Re: **Groundwater Impacts of the Proposed Rosemont Mine**

Technical Memorandum
Review of the Proposed Rosemont Ranch Mine
Groundwater Models

Prepared for Pima County and Pima County Regional Flood Control District

Figure 1: Snapshot of M&A Figure 94 showing recharge through the mine facilities during the post-mining period.

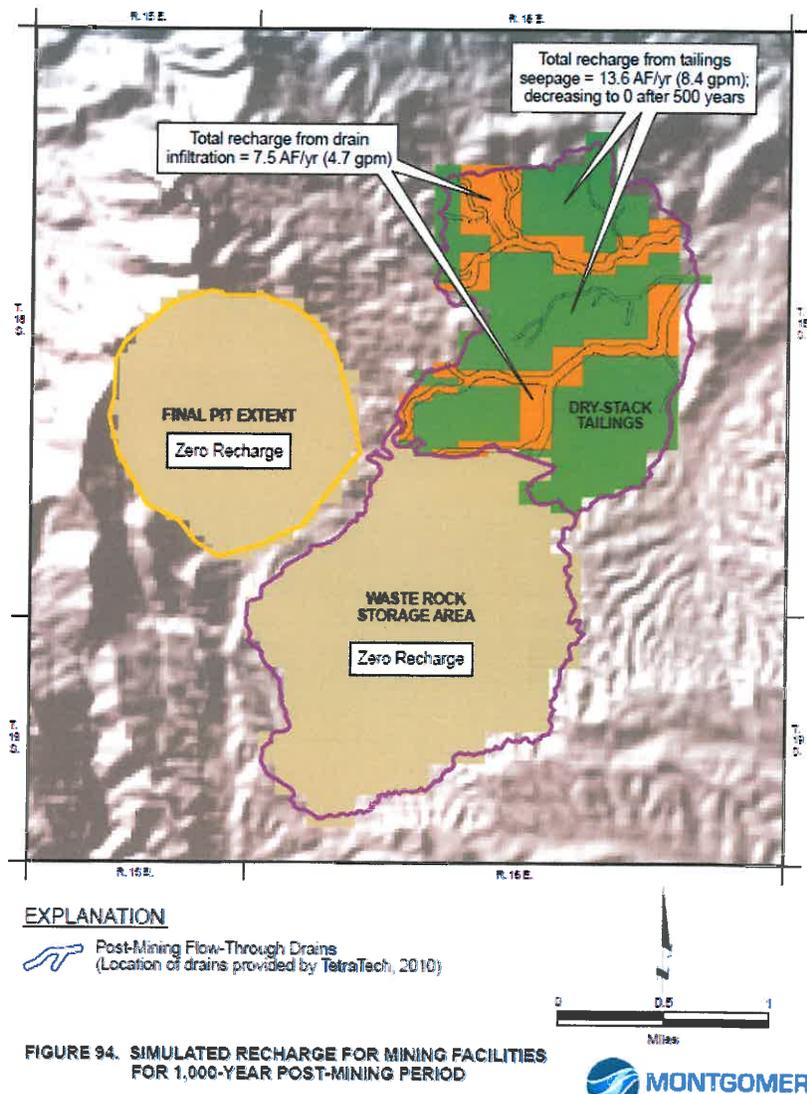
M&A (2010a) Figure 94 (Figure 1) shows the simulated recharge during mining. *Comparison with M&A Figure 93 suggests some significant problems.* If the pit and waste rock area is simulated as having zero recharge, the total recharge in the project area would decrease substantially due to mining; M&A states there is about a 75 af/y decrease to recharge through the mine facilities. At least during mining, there would be recharge through the pit walls. During pit lake formation, recharge would occur through the pit wall above the lake. Simulating no recharge through the waste rock dump implies that the reclamation shuts off seepage. If the rock is placed dry, some years may be required until recharge commences, but recharge would eventually return to pre-mine rates¹.

Figure 2: Snapshot of model cross-section from M&A (2010a) Figure 5.

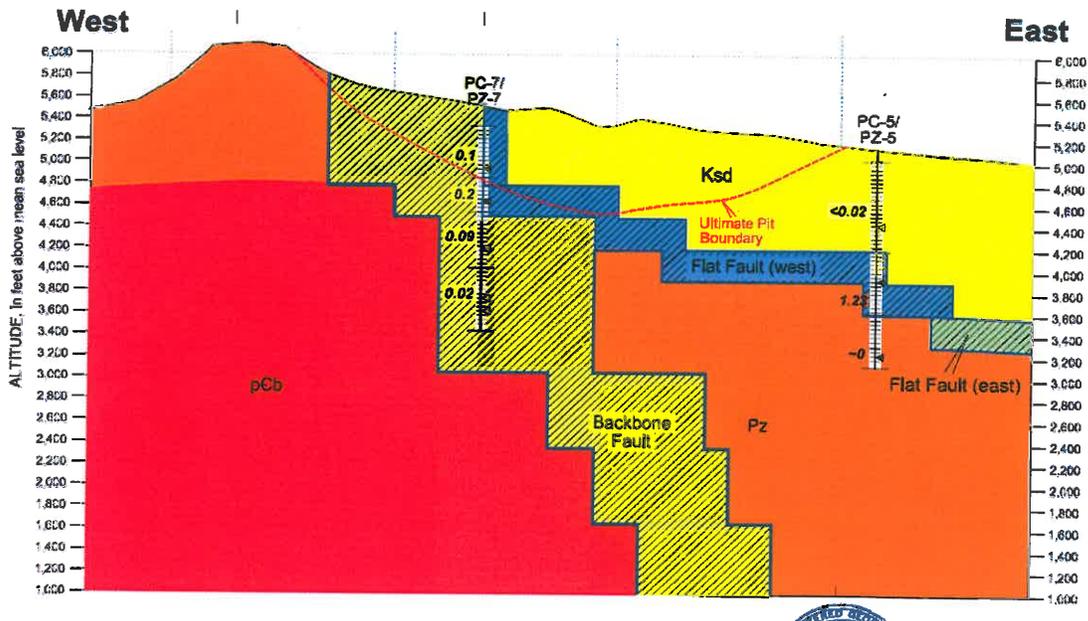
M&A made several important changes in the hydrogeologic units between the 2009 and 2010 model. They used the same ten units as in 2009, but appropriately added two new fault zones as parameter zones, the Backbone and Flat Faults (these names appear to have been created by Rosemont). These zones coincide with recommendations by Myers to consider anisotropic conditions around the pit as caused by faulting. The Backbone Fault is an area of fractured Paleozoic rock west of and in the west half of the pit area; it has significant north-south anisotropy and significant vertical conductivity due to the tilt of the fractured formations (M&A, 2010a, p. 18). The general properties are correctly interpreted (M&A, 2010a, p. 48) with the final conductivity estimate in the model. The Flat Fault is low angled sloping gently to the east. M&A (2010a) simulated these fault zones as parameters in the model that intersect (Figure 2).

M&A does not simulate the quartz-porphphyry dike as Tetra Tech does, and as discussed below in the section regarding the Tetra Tech modeling effort. Ultimately in this model, the Ksd and Kv formations control flow to Davidson Canyon and because their calibrated conductivity is low, the impacts move slowly in that direction. The calibrated conductivity east and northeast of the pit is 0.01 to 0.001 ft/d in the higher elevations and 0.001 to 0.0001 ft/d in the lower model layers. This revised model however does not surround the pit zone with bedrock having conductivity less than 0.0001 ft/d, as criticized by Myers (2010). The Davidson Canyon fault zone is modeled with much higher conductivity in the top four layers (M&A, 2010a, Figures 81-85). The thickness depends on geologic mapping; low conductivity bedrock underlies the fault zone.

Figure 3: Snapshot from M&A (2010a) Figure 3 showing Tqi, the quartz-porphry dike.

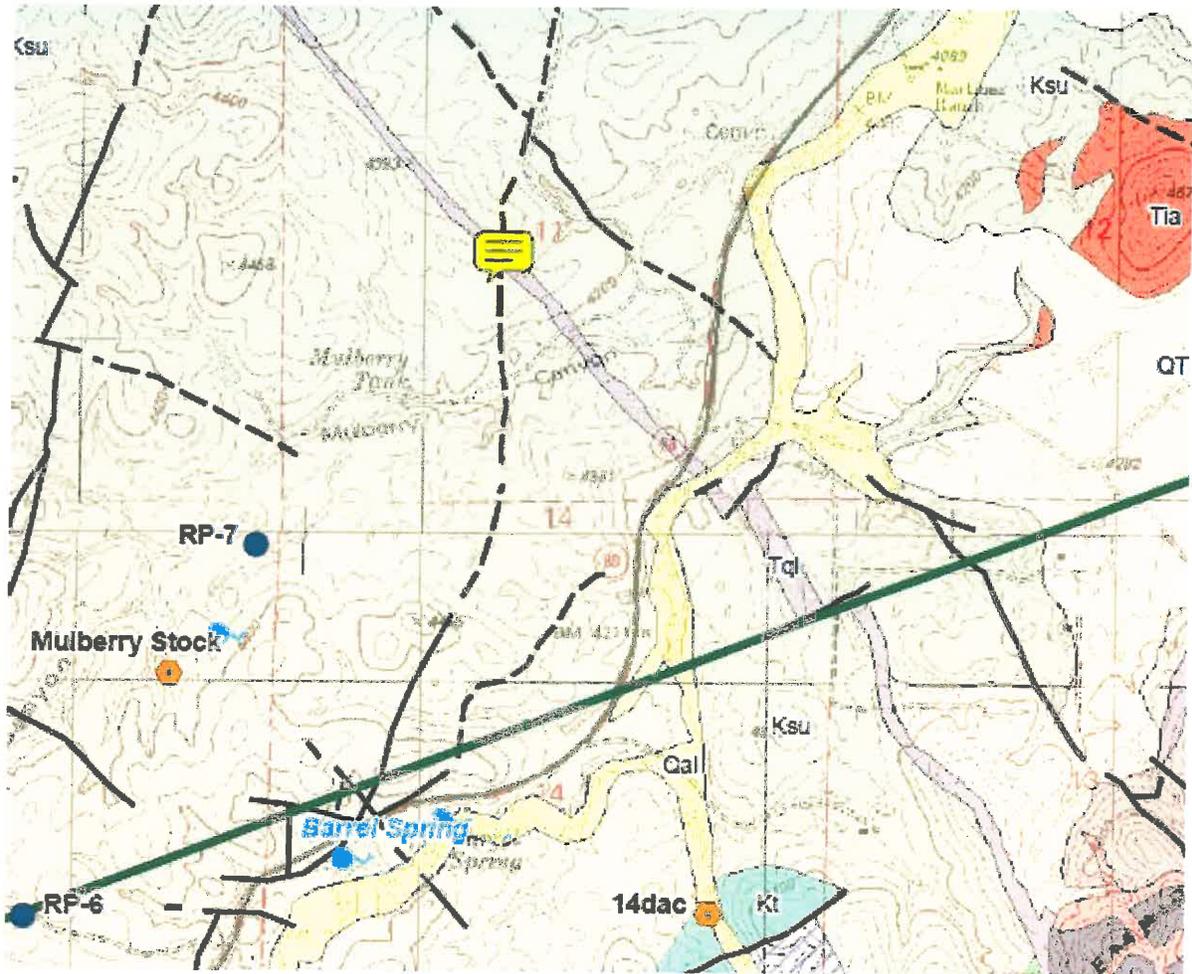
This passage describes the dike as a flow barrier, but there is really no data provided to support this conceptualization. In fact the maps of the dike (Figures 3 and 4) show that the quartz-porphyry dike is not continuous across Davidson Canyon. It has been faulted and offset so that there could be flow paths through the dike.

There are no field observations of the fracture density, thickness of the dike, or its hydraulic properties. If the dike were a barrier, water would dam on the upgradient side and be lower on the downgradient side; this would form a step in the contours. None of the groundwater contour maps (M&A, 2010; Myers, 2007) show such a step and no pairs of wells, up- and down-gradient of the dike, demonstrate it. There would be significant major springs along it if it were as effective as described herein; the very low flow springs observed in the area do not qualify as proof of its imperviousness. *Tetra Tech acknowledges “there has been no hydraulic testing”, therefore before using it as a major barrier in the modeling they should verify it. The conceptualization and parameterization of this dike in the model is not supported by available data.*

- Rosemont should conduct test of the quartz-porphyry dike that crosses Davidson Canyon. This should include several boreholes to assess its density and thickness. The tests should include long-term pump tests with multilevel pumping on one side and multilevel monitoring on the others; the design could be similar to the long-term pump test completed near the pit. This test would help determine at what levels the dike is a flow barrier, if any.

Figure 5: Snapshot of Tetra TEch Figure 5-4 showing initial recharge distribution.

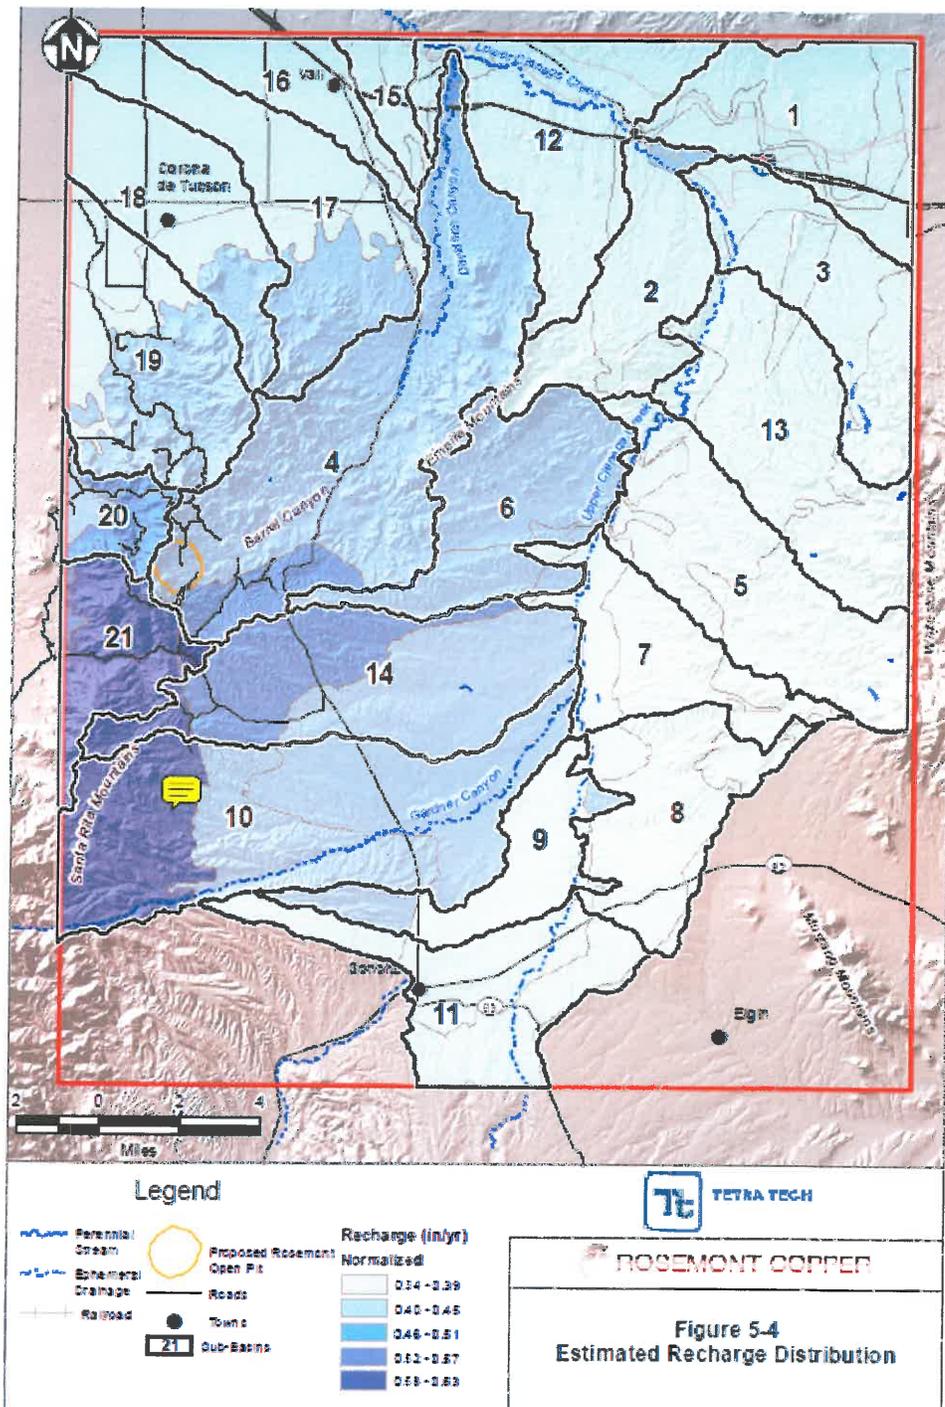
Tetra Tech (2010a, p. 49) used the M&A recharge estimate of 10,100 af/y within their model domain. *They suggest they distributed the recharge using a GIS and hydrologic soil group classification, but provide no details.* Their resulting Figure 5-4 shows that their initial recharge varies from 0.34 to 0.66 in/y around the model domain (Figure 5). The ranges shown on the figure are due to them initially using 58 recharge zones. The distribution obviously does not include any mountain front recharge. *It appears to primarily depend on elevation, with high elevation areas having the highest recharge. There are high recharge rates along the crest in the areas of granodiorite geology, which M&A had properly set as having very low recharge rates. Tetra Tech apparently forced recharge into non-receptive bedrock and ignored the runoff that recharges at the mountain front; their initial conceptual model of recharge in the area is incorrect.*

Figure 6: Snapshot of Tetra Tech Figure 6-24 showing the calibrated steady state recharge distribution.

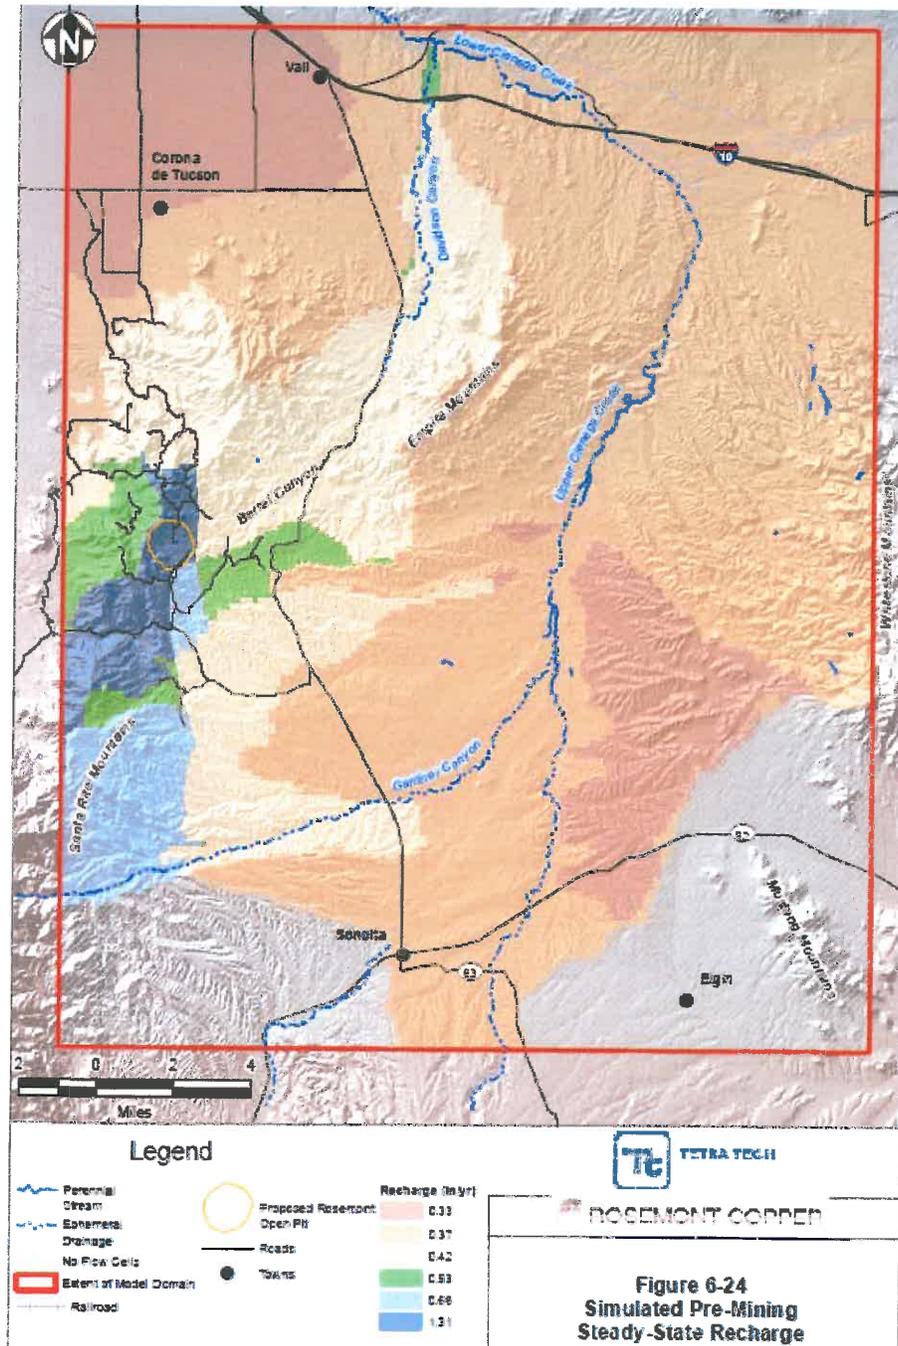
Tetra Tech (p. 60) modified the recharge distribution during calibration. They do not specify the reason for changing the recharge distribution other than to “maintain a reasonable balance with simulated hydraulic conductivity values” (*Id.*). The total recharge in the calibrated steady-state model supposedly was 9,900 af/y which is less than the initial estimate 10,100 af/y (*Id.*). Figure

6 shows the calibrated distribution. *The primary change appears to have increased recharge in the Backbone Fault zone significantly with small reductions over all the Cienega Basin. There is still too much recharge in the granodiorite regions along the mountain crest.*

Figure 7: Snapshot from Tetra Tech Figure 5-5 showing Tetra Tech's simulated post-closure recharge in the project facility area.

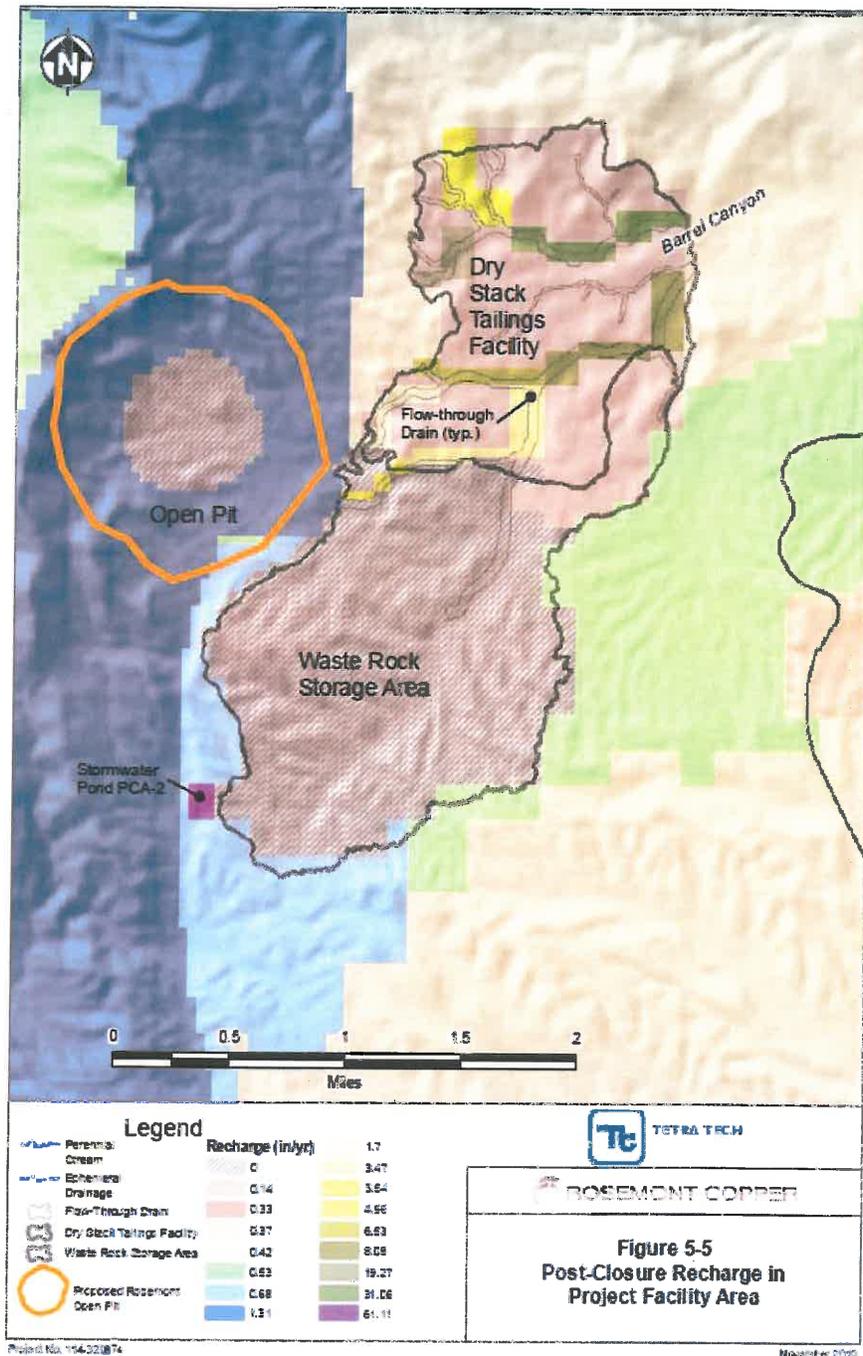
Overall, they estimate that post-closure recharge in the Project facilities will be 81 to 95 af/y greater than pre-mine conditions (Tetra Tech, p. 50). This appears to be due to the tailings draindown and seepage from the stormwater drains. *As explained in the previous paragraphs, this appears to be new recharge within the pit lake capture zone. This new recharge would go to fill the pit lake and minimize the effects of filling the pit lake on the regional groundwater table. The additional recharge simulated in the Tetra Tech model during the post-mining phase biases the model in a way that decreases the extent of drawdown simulated due to the mine.*

ATTACHMENT 2

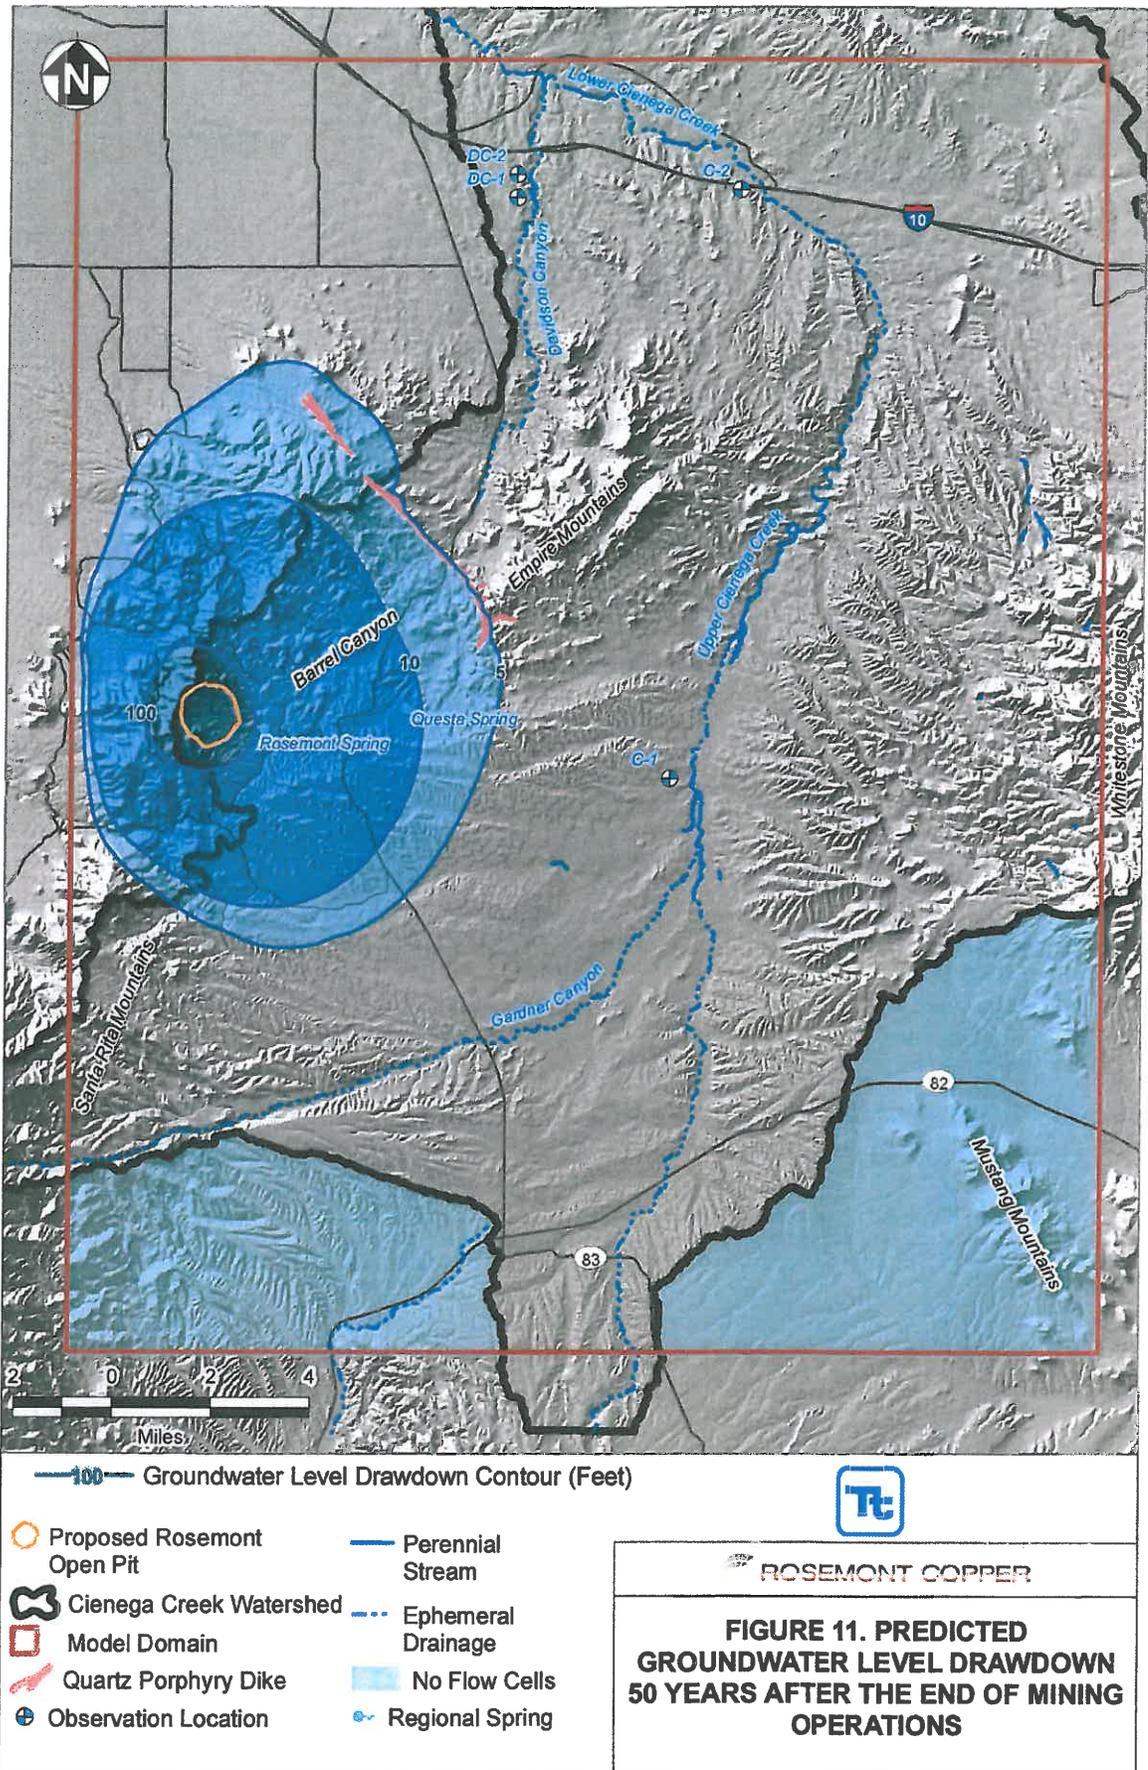
An assumption contained only in the model proposed by Rosemont's consultant Tetra Tech is that a dike crossing Davidson Canyon will limit the impacts of the mine on aquifer downgradient (north) of the dike (Attachment 2). The extent of these impacts is of concern
